MISSISSIPPI RIVER-GULF OUTLET, LOUISIANA

GENERAL DESIGN MEMORANDUM NO. 2
SUPPLEMENT NO. 3
BAYOU LA LOUIRE RESERVATION

February 1968

SUBJECT: Mississippi River-Gulf Outlet, La., General Design Memorandum
No. 2, Supplement No. 3, Bayou La Loutre Reservation

DESIGN LOAD VS TIP ELEVATION AND SPACING

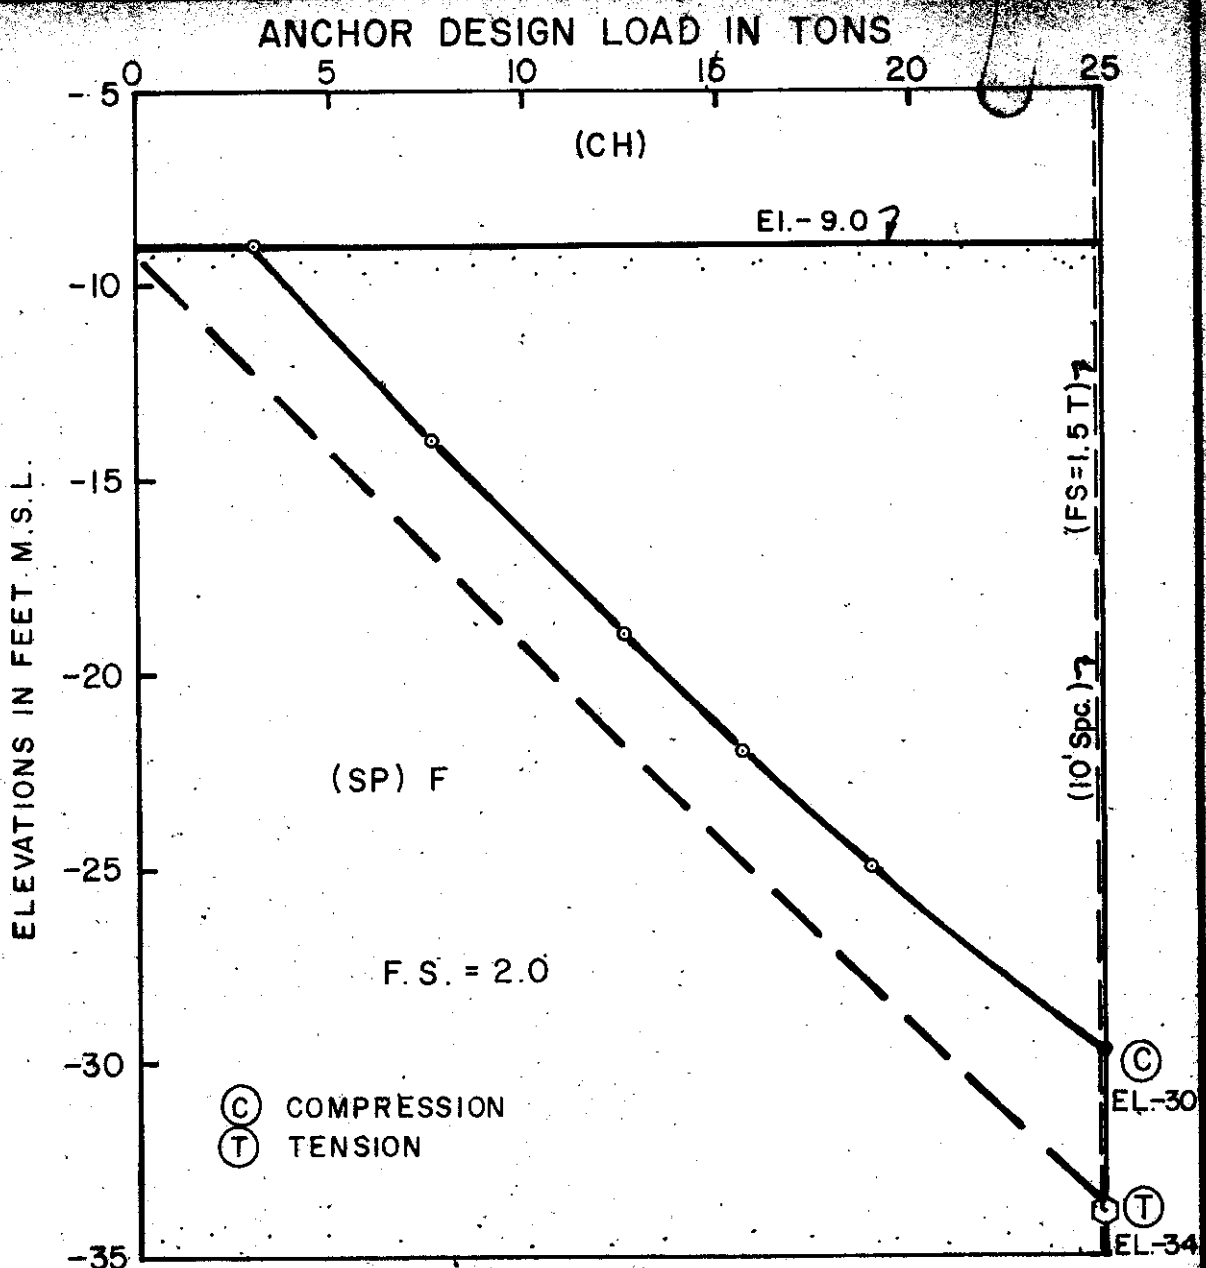
2. Sec. III, Paras 8 and 9, Page III-2. To allow for increased load in the anchor rods due to drag on the anchor, redistribution of earth pressures from that assumed in design, and stresses induced during backfill operations, the design load in the anchor rods should be increased 50 percent. The anchor tie-back system should also be designed for this increase in anchor load, with the required pile penetrations based on a factor of safety of 2.0 in lieu of 1.5. Based on the above increase in anchor load, it appears that a two-inch diameter anchor rod would be required.

2. Section III, paragraphs 8 and 9, page III-2. The anchor tie-back system will be designed for 1.5 times the load shown in the design memorandums. The size of anchor rods will be increased to 1 7/8" diameter and the wales will be 10U25. The pile penetrations will be based on a factor of safety of 2.0 using 1.5 times the load. Due to the increased penetration into the sand, 12BP53 steel piles will be used in lieu of the 12" by 12" concrete piles as shown. The reference to prestressed concrete piling should be deleted from paragraph IV-3. Inclosure 2 shows the required anchor pile design penetrations.

REVISED BY DIVISION COMMENTS
1st INDORSEMENT, 19 MARCH 1968
PARAGRAPH 2

**DEWATERING SYSTEM FOR
 CONSTRUCTION OF BOAT RAMP
 IN THE DRY**

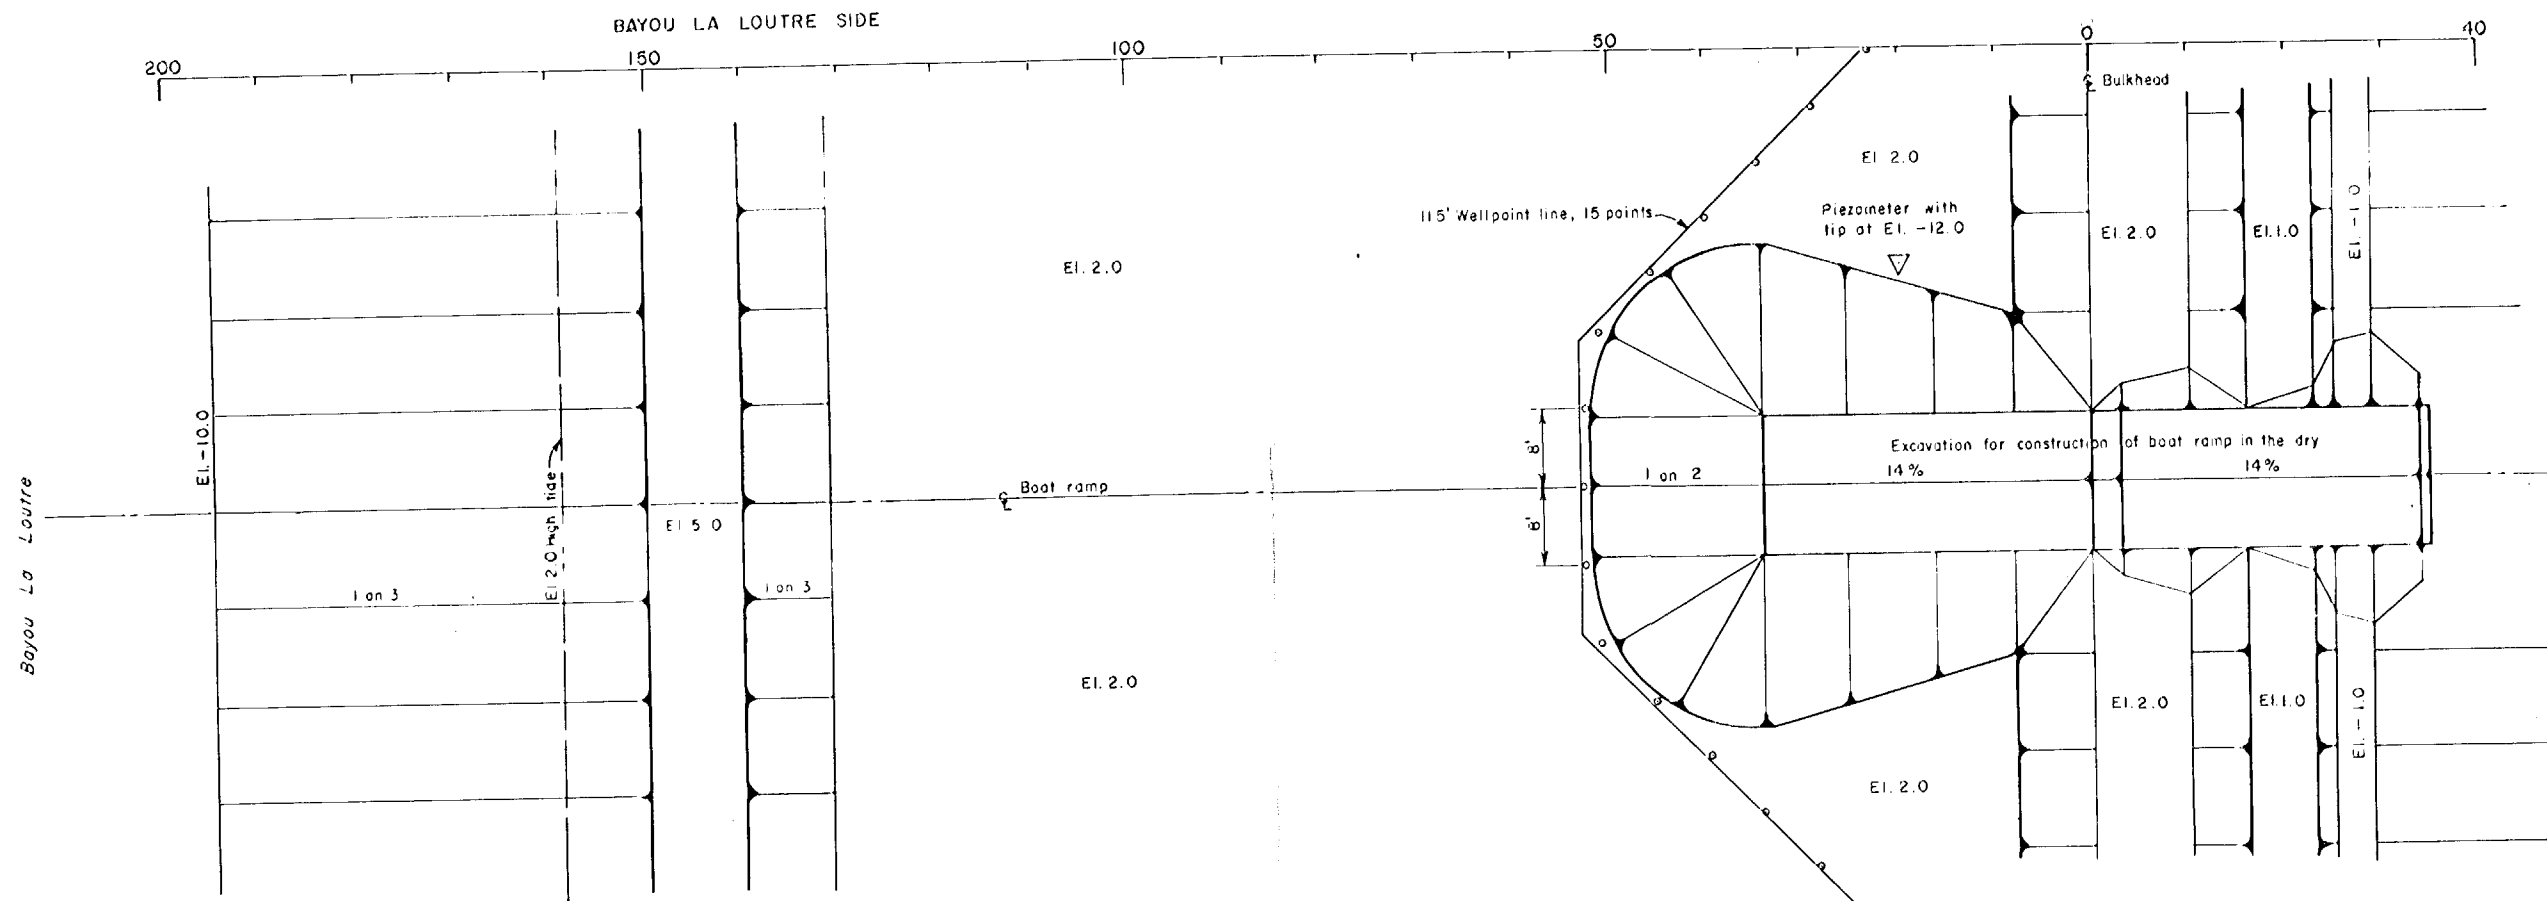
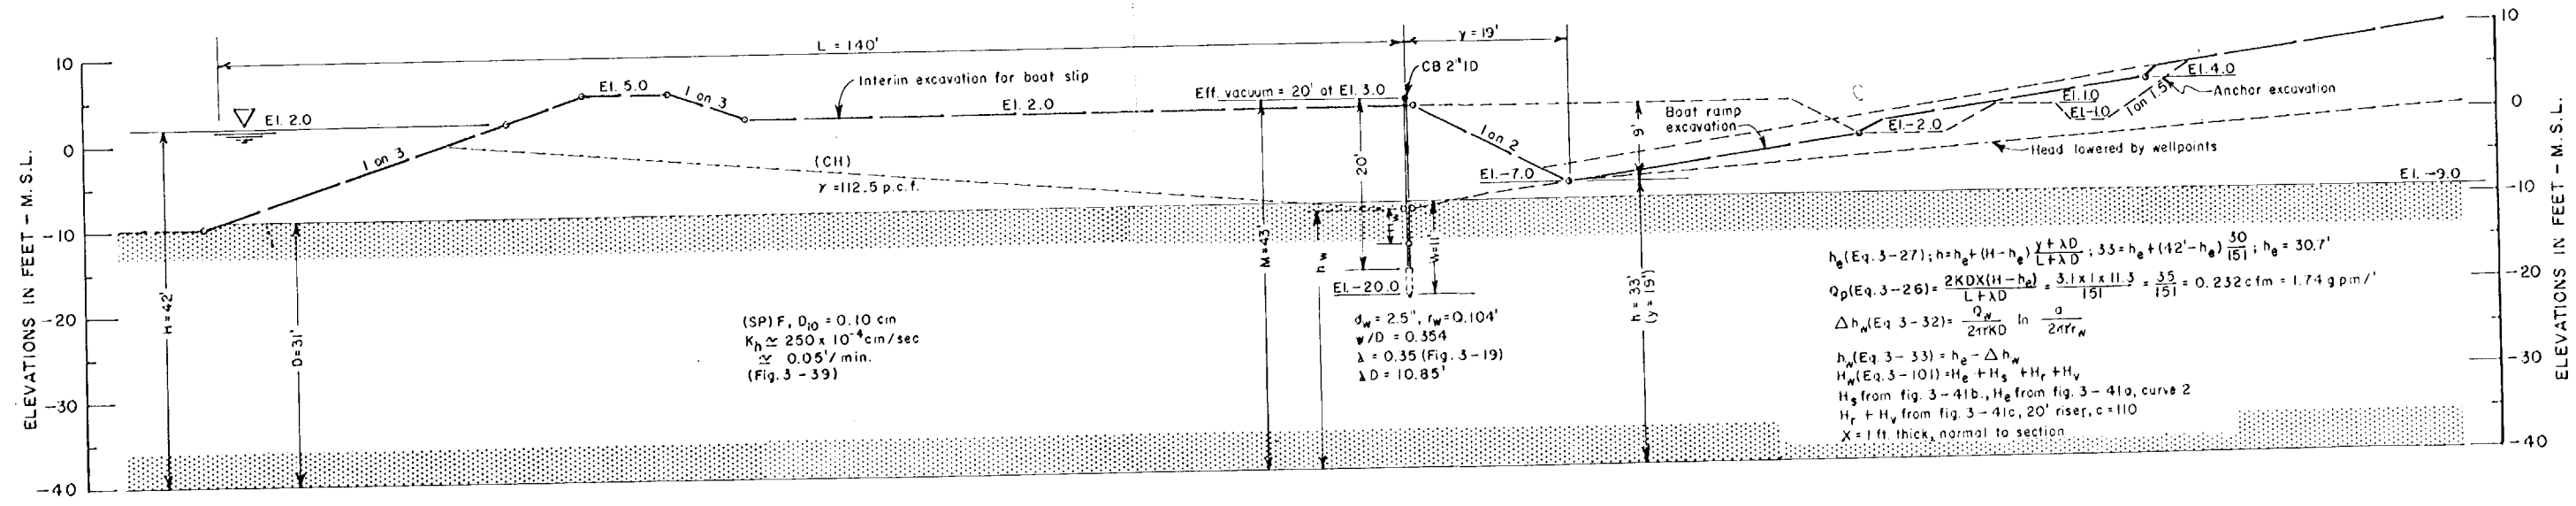
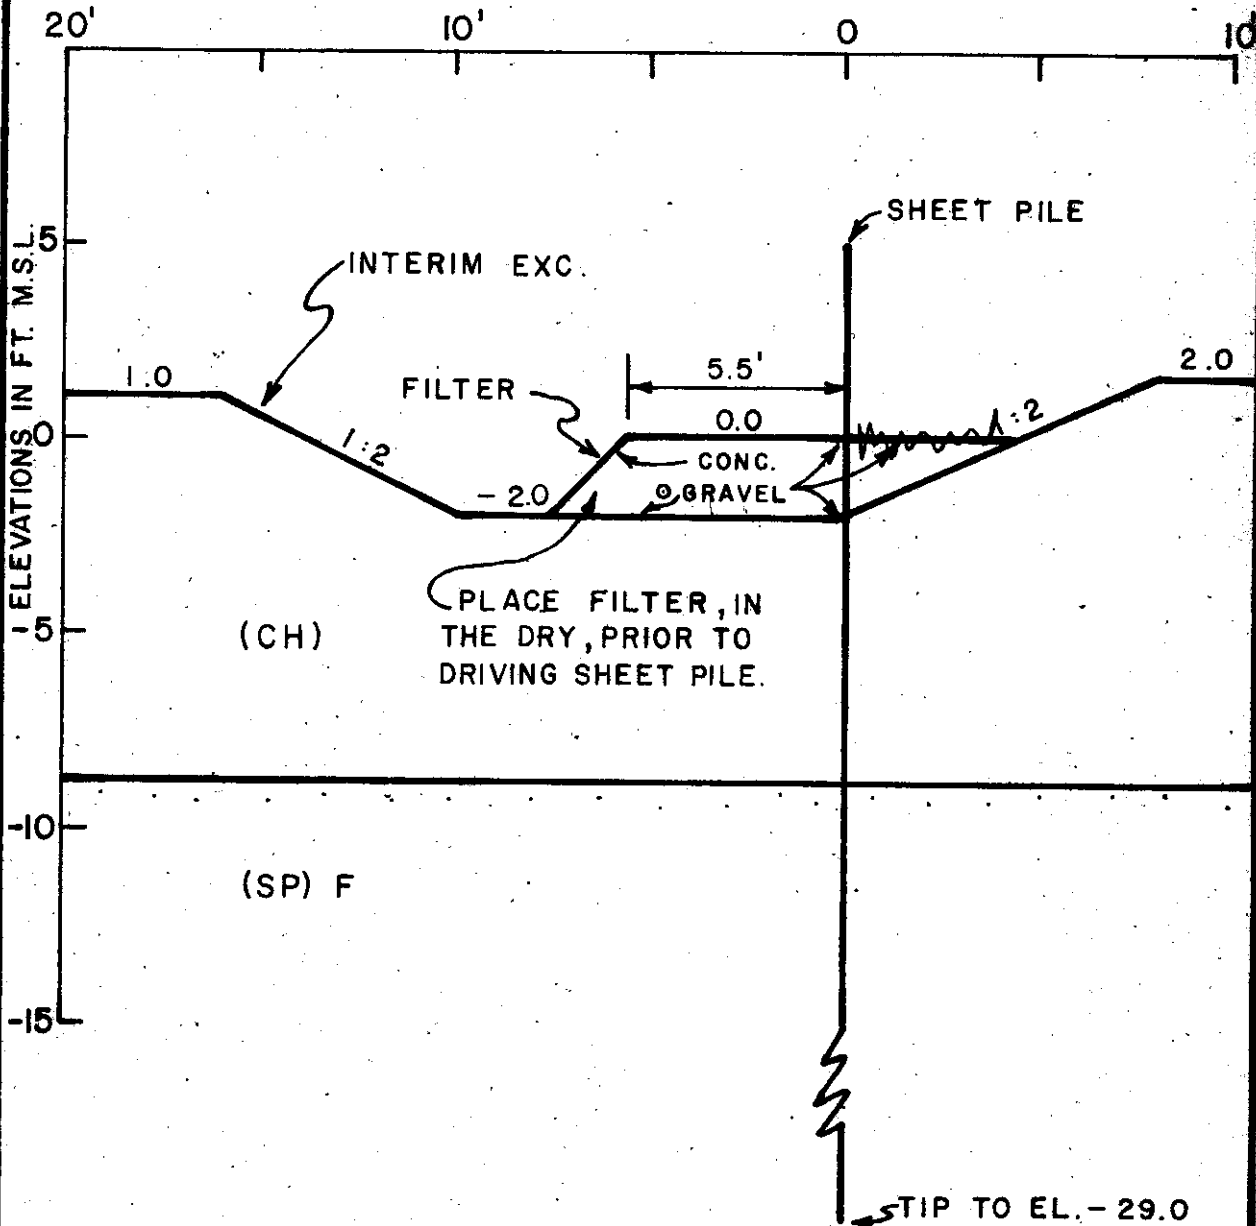
1. Actions taken to satisfy comments in the 1st Ind are satisfactory, subject to the following comments on the 4th Indorsement.
2. Para 2. The reference to para IV-3 should apparently be to para III-9.
Para III-9 & Plate IV-3
3. Incl 3. The values of h_e and Q_p are calculated on the basis of a partially penetrating slot. However, the values of Δh_w are computed for conditions of a fully penetrating system. This discrepancy should be resolved.
4. Incl 4. If the head in the sand is lowered as indicated on Incl 3, it would not be necessary to place the filter as indicated to control seepage gradients adjacent to the sheet piling during construction. Our original comment on the possibility of this condition developing was to point out that such a condition could develop if the piezometric head in the sand was not lowered with a well point system.

3. Sec. III, Paras 14a and 14b, Page III-3. With the method and sequence of construction indicated, it will not be possible to construct the boat ramp in the dry without a dewatering system utilizing well points. The need and cost of such a system have not been presented in the DM. Also, with the bulkhead sheet piling penetrating into the sand, seepage into the adjacent interim excavation could occur due to piping along the sides of the piling during periods of high tide. In view of the above, the DM should be revised to present the required dewatering facilities necessary to accomplish the work in the proposed manner. Should the cost of dewatering be excessive in relation to the magnitude of the work requiring it, consideration should be given to alternate methods of providing the required facilities without the need for dewatering.

1. The following is offered in response to the comments in the 5th Ind.
2. Paragraph 2. The reference applies to paragraphs IV-3 and III-9.
3. Paragraph 3. The referenced discrepancy has been resolved. The calculation for a partially penetrating well is as follows:

$$\Delta h_w = \frac{Q_w \theta a}{K.D.} (\text{Eq. 3-32a}); \theta a \text{ from Fig 3-38, } \frac{a}{r_w} = \frac{12}{0.104} = 115, \frac{W}{D} = \frac{11}{31} = 0.355$$

$$\Delta h_w (a=12') = \frac{2.78}{0.05 \times 31} (2.0) = 1.79 \times 2.0 = 3.58', h_w = h_e - \Delta h_w = 30.7' - 3.58' = 27.12'$$

$$h_w - H_w = 27.12' - 3.96' = 23.16' > 23' (0'K')$$

3. Section III, paragraphs 14a and 14b, page III-3. Inclosure 3 contains an analysis for the wellpoint line required so that the ramp can be constructed in the dry. Inclosure 4 contains the revised filter gravel section for control of seepage gradients adjacent to the sheet pile. Accordingly, the sequence of construction as shown on Plate III-1 will be revised as follows:
